**FINDINGS AND RECOMMENDATION  
OFFICE OF PLANNING AND ZONING  
ANNE ARUNDEL COUNTY, MARYLAND**

**CASE NUMBER:** 2024-0223-V

The applicant is requesting a variance to allow a dwelling addition (multi-level deck with a screened porch and platform) with less setbacks and buffer than required and with disturbance to slopes of 15% or greater on property located at 1313 Saint Josephs Court in Crownsville.

# BEER RESIDENCE

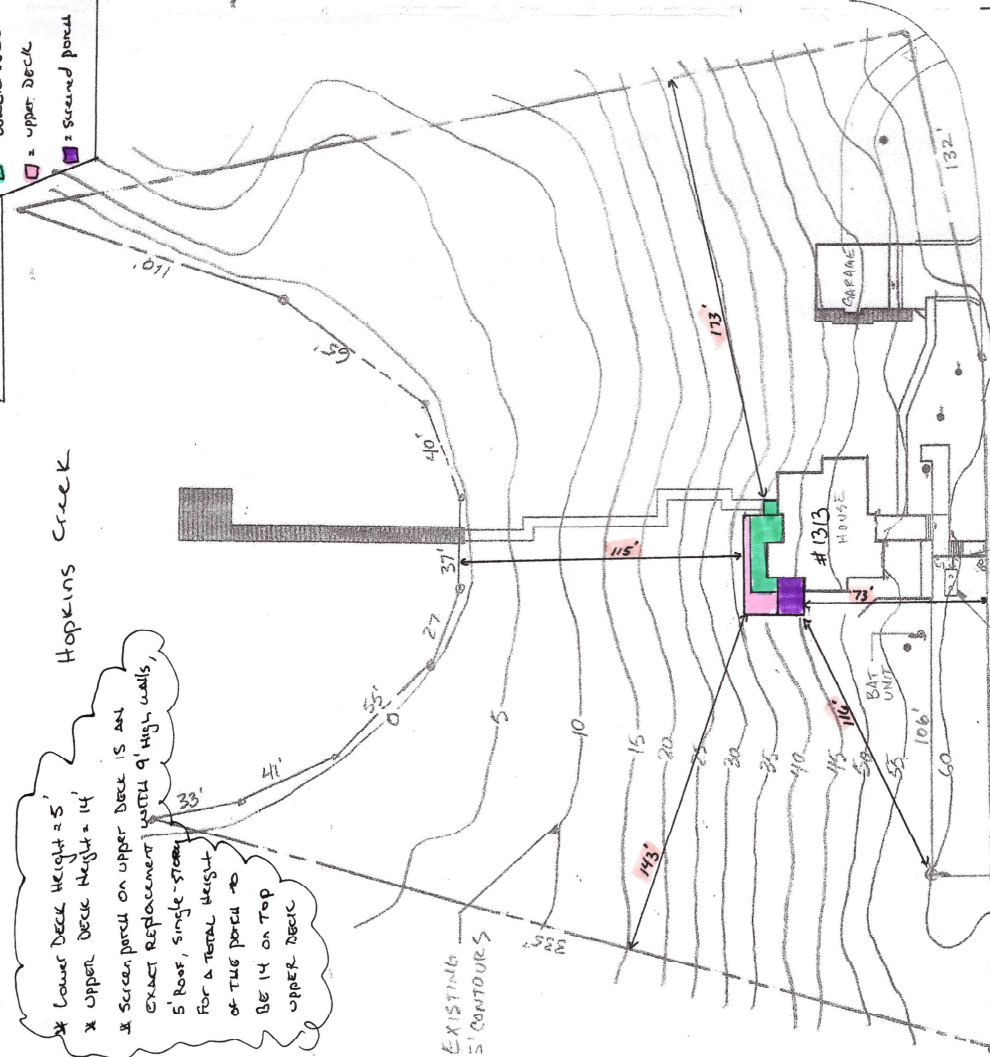
The **Development Division (Critical Area Team)** commented that there is no objection to the replacement/repair of the existing improvements within the existing footprint. The existing conditions site plan does not depict the second level deck and based on the information available to us, the upper deck is the same depth (12') as the lower deck. The sight plan shows the upper deck to be 14' deep. This Office would not approve this expansion.

The existing conditions site plan does not depict the second level deck and based on the information available to us, the upper deck is the same depth (12') as the lower deck. The sight plan shows the upper deck to be 14' deep. This Office would not approve this expansion.

\* EXISTING CONDITIONS

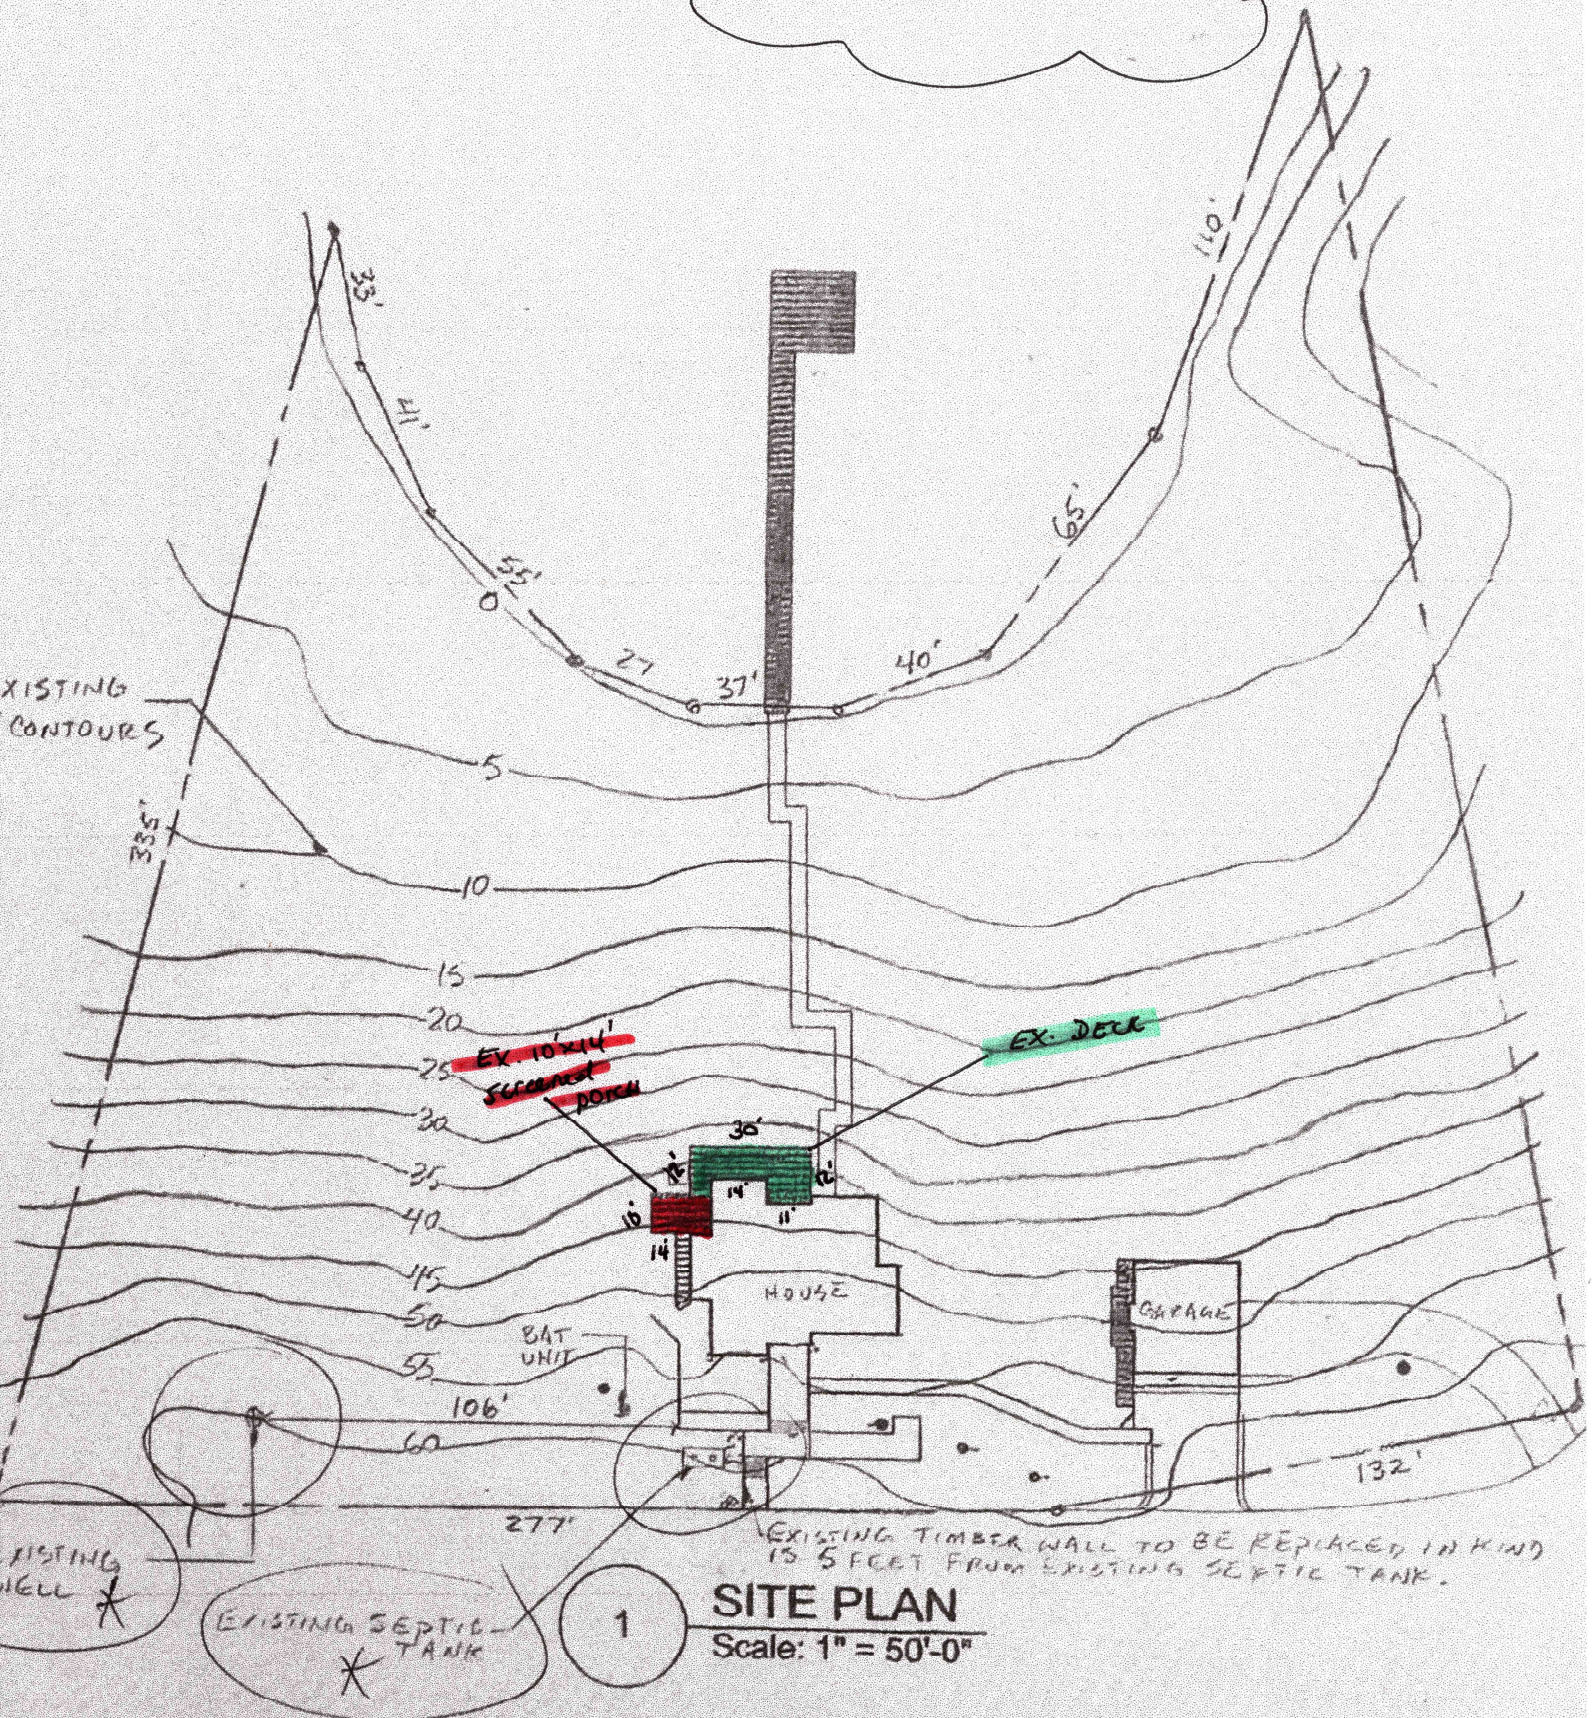
**From Zoning:** The site plan needs to clearly show the existing and proposed improvements as it appears that the plan only shows the proposed. It is suggested that the plan show a detail of existing and a separate detail of the proposed so this Office can clearly differentiate what is currently there and the difference to what is proposed. Steep slopes should also be clearly delineated, possibly with shading to determine their exact location. The site plan also needs to show the LOD (limit of disturbance) with calculations on how much expanded buffer and steep slopes will be disturbed by the project.
